Addendum No. 2
March 20, 2026

Project: Union County Courthouse Addition and Renovation
Elk Point, South Dakota
Architecture Incorporated Project Number 0728.2893.20

Architect: Architecture Incorporated

7 PUBLIC WINDOW
4.50 SCALE: 1" = 1'-0"

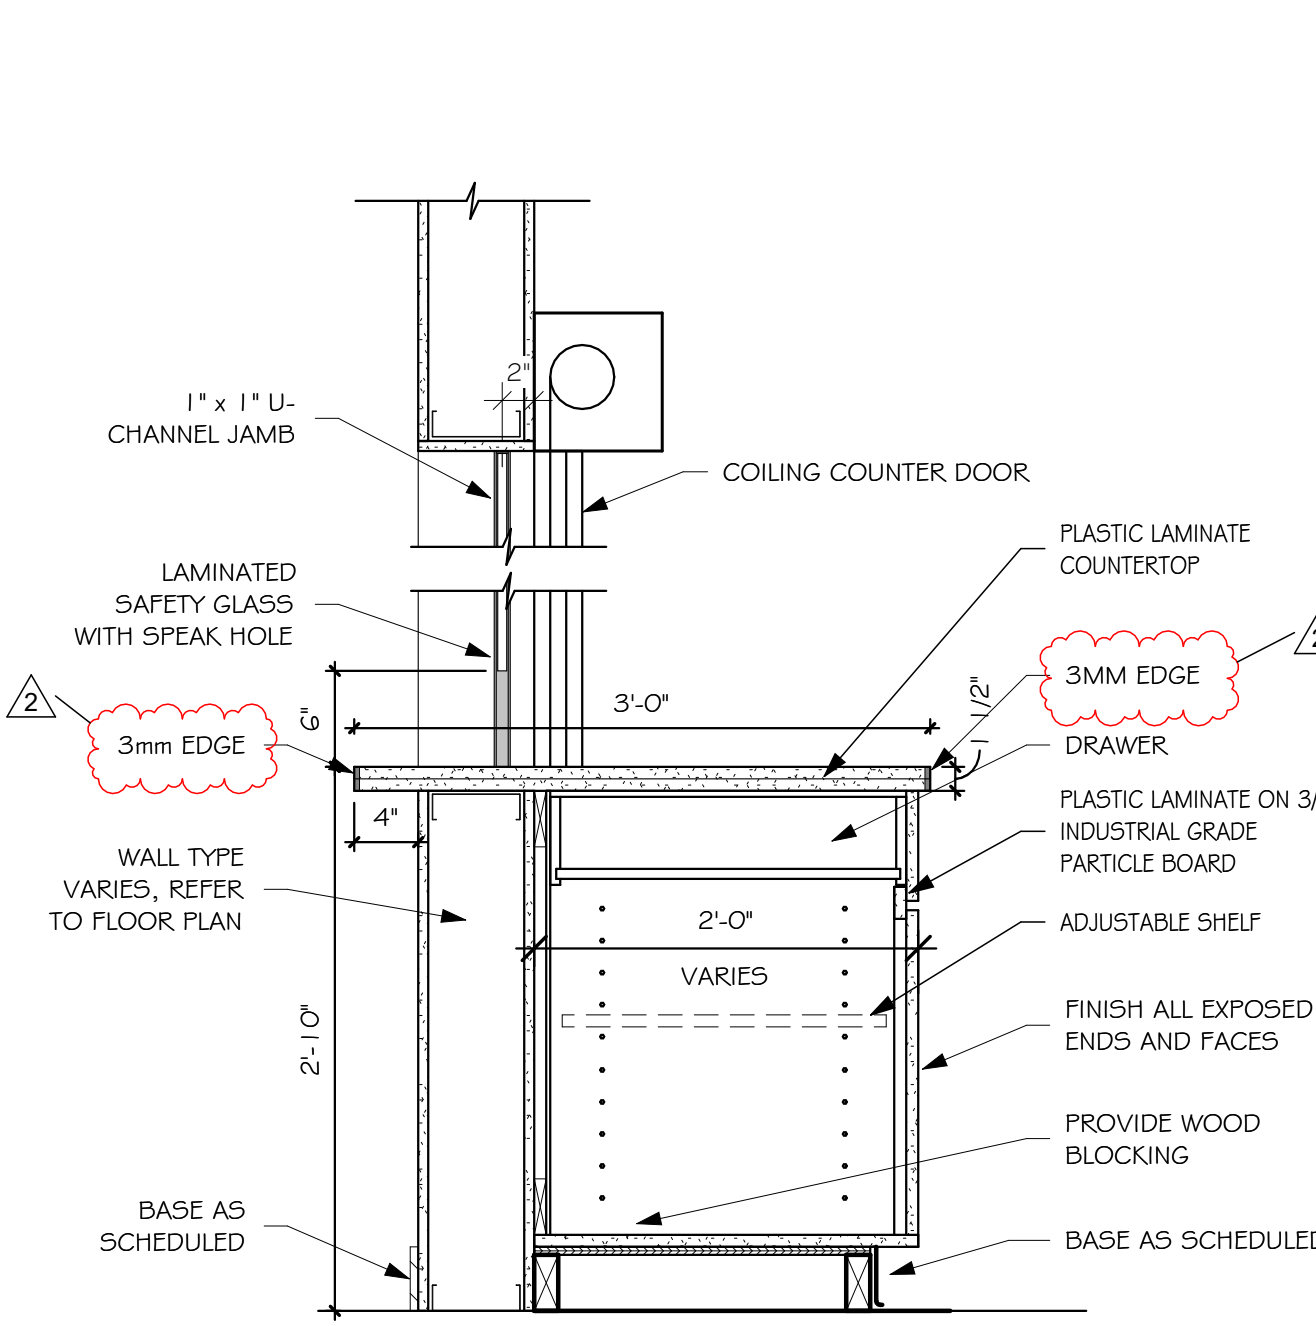
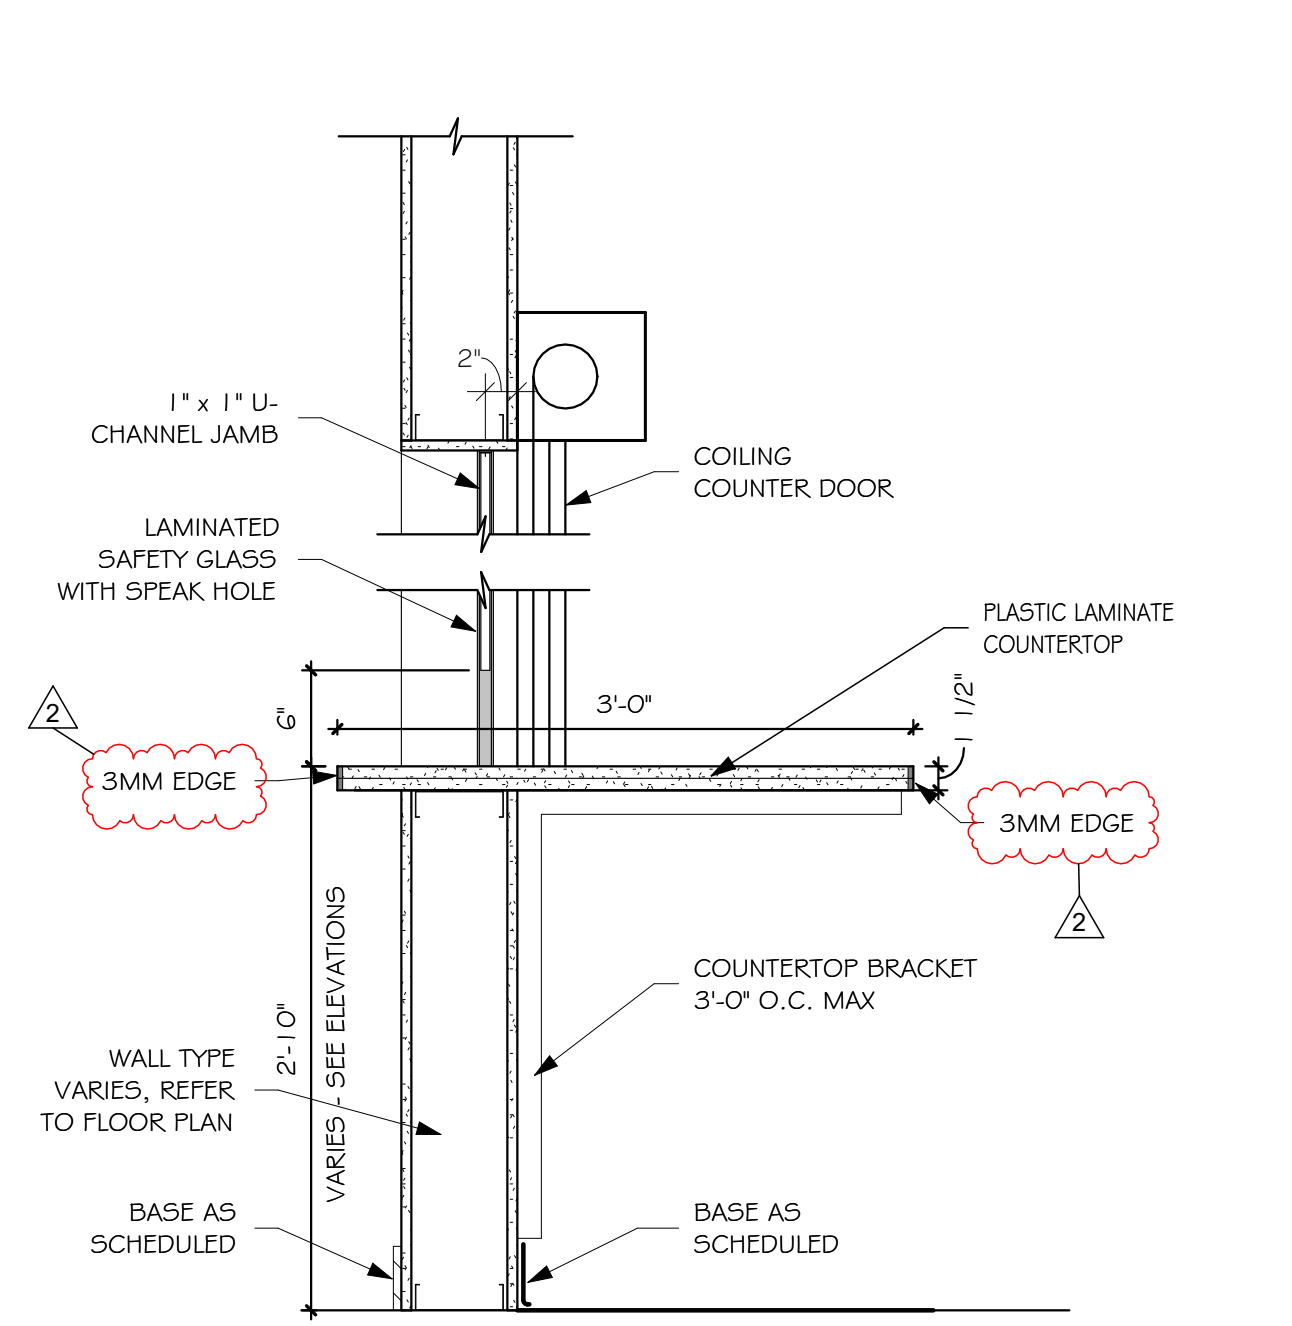
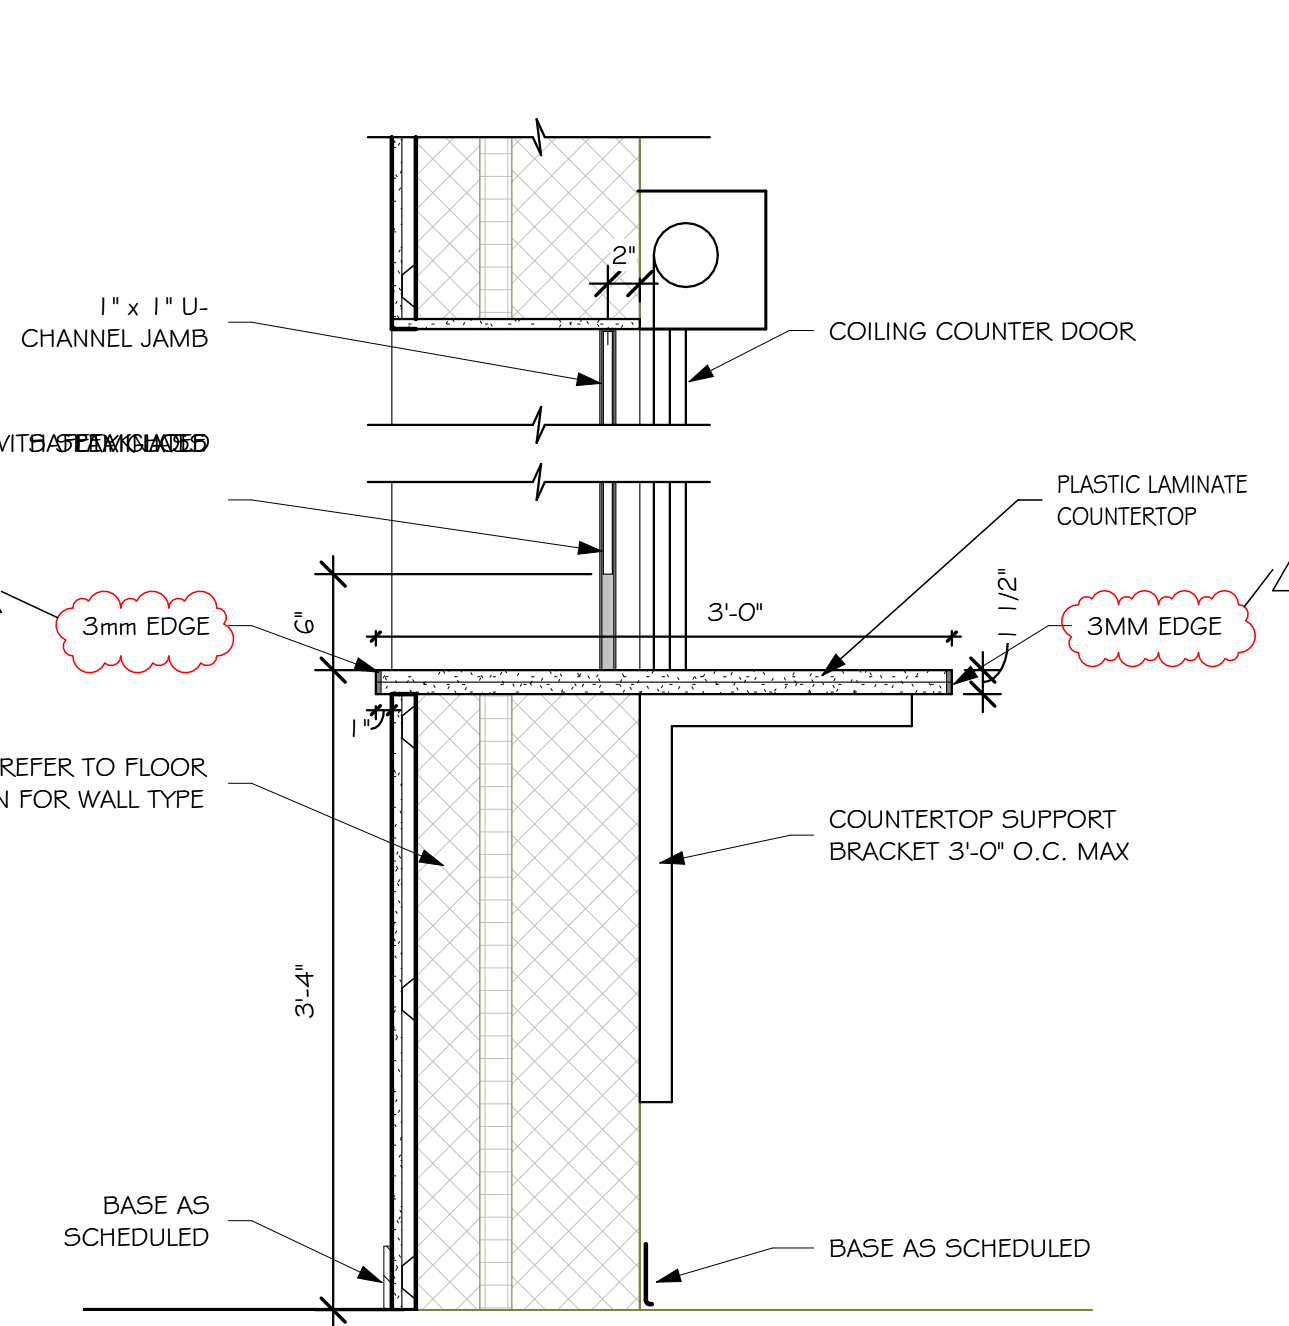
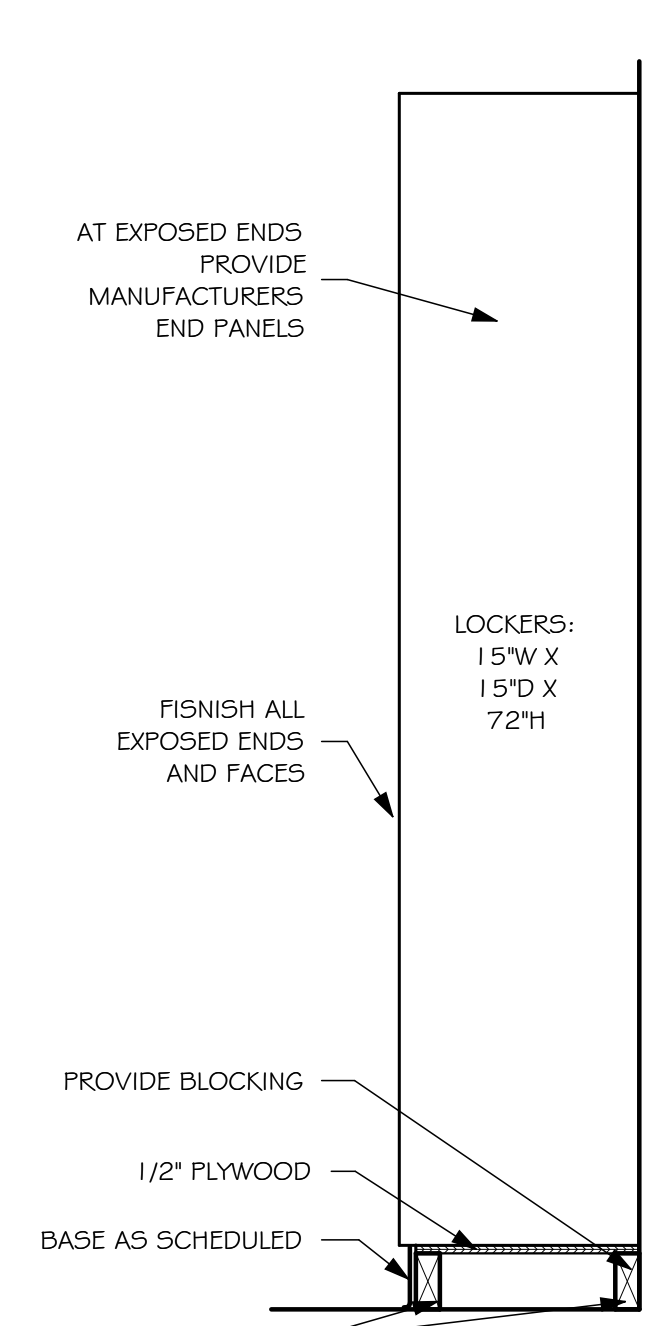
- a. Revise countertop edge profile at public windows to a 3mm edge on each side. Reference details 7/4.50, 8/4.50, 9/4.50, and 10/4.50.
7. DRAWING SHEET 5.10 – EXTERIOR ELEVATIONS
